Project: 260006
Document#: 260006_IRR_A007059364
Rev: A

RE: Application Number: A007059364
 43-49 Primrose Street, SHERWOOD QLD 4075
 Engineering Response to Information Request

PROJECT
PROPOSED UNIT DEVELOPMENT
43-49 PRIMROSE STREET
SHERWOOD

REMOVE AND CONSTRUCT PROPOSED 6.80m
WIDE CUSTOM DRIVEWAY CROSSOVER
GENERALLY IN ACCORDANCE WITH TYPE B1.
REFER BCC STD DWG BSD-2021

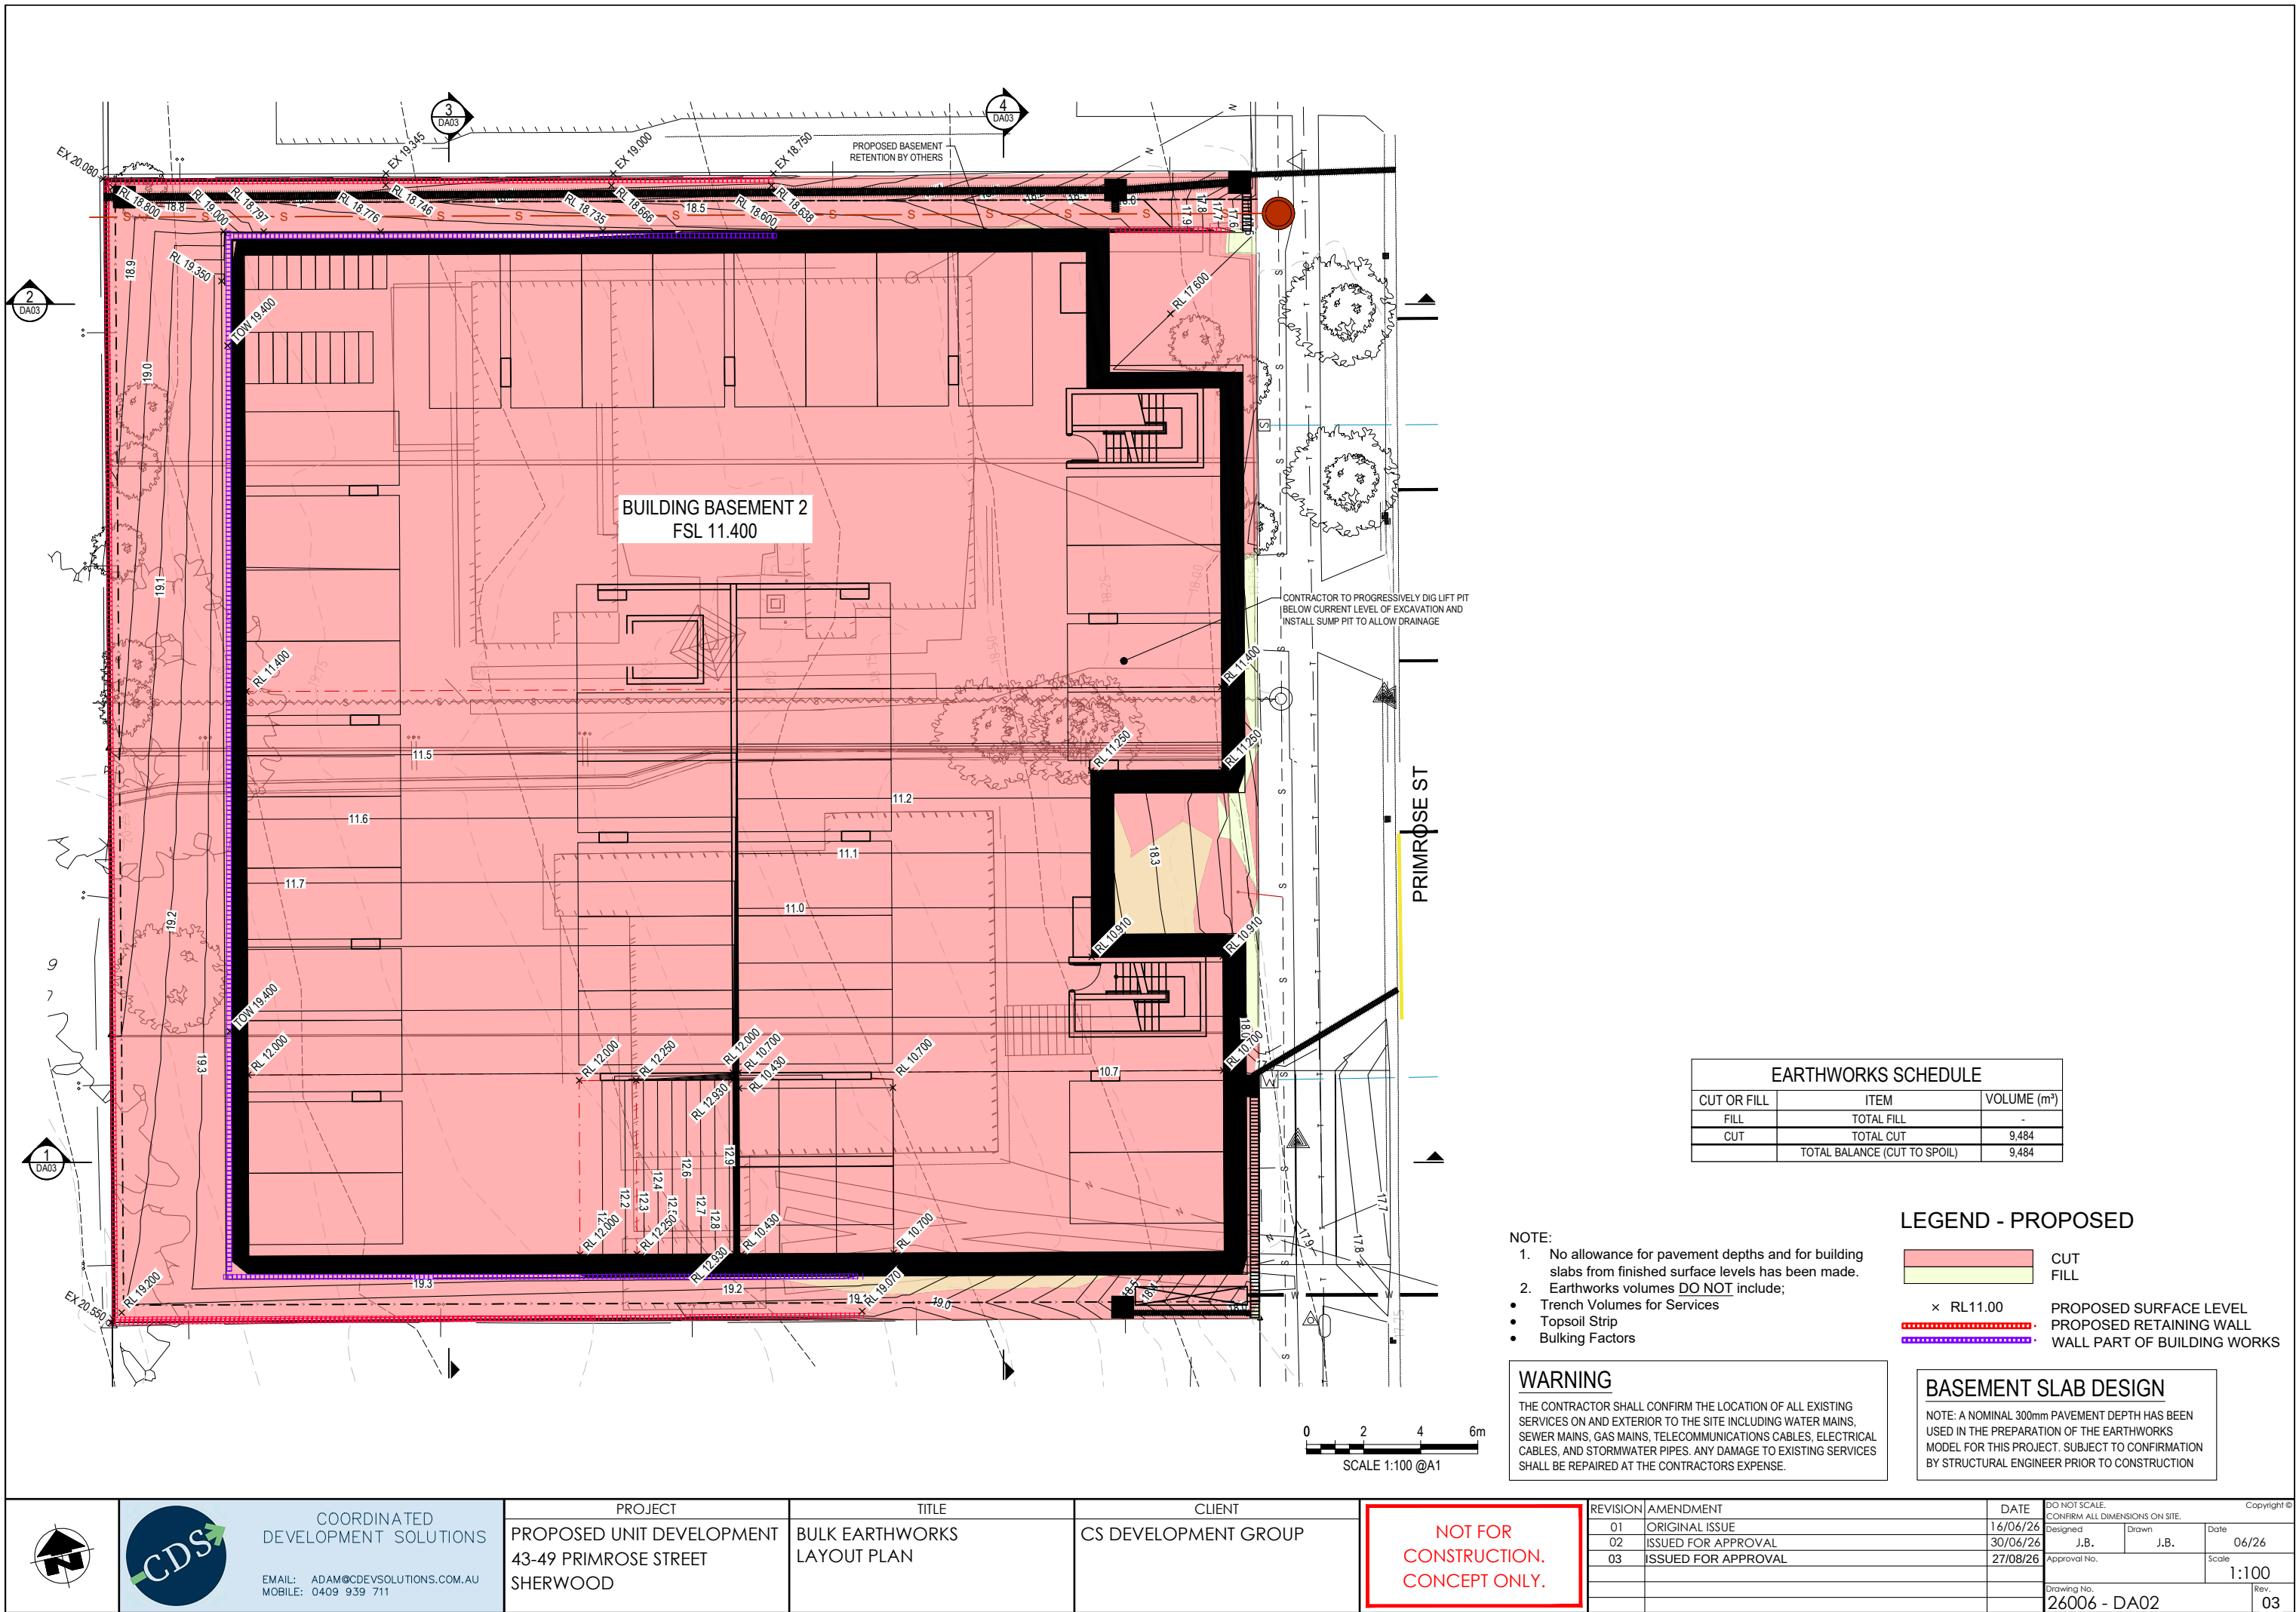
Provide amended architectural and Engineering plans demonstrating the development has a minimum 6.5m wide driveway crossover with Type B2 wing tapers and two-way aisle/carriageway which is a minimum of 6.5m wide between the southern wall and northern structural column.

The attached amended Civil Works Plan 26006-DA01 shows the driveway crossover widened to 6.80m, matching the crossover width adopted in the BMC swept path analysis and the amended architectural plans. Four delineated on-street parking bays with line marking in accordance with AS2890.5, and a 6.5m yellow “no parking” line to the north of the crossover, are also shown, consistent with the No Stopping Zone recommended in the BMC response.
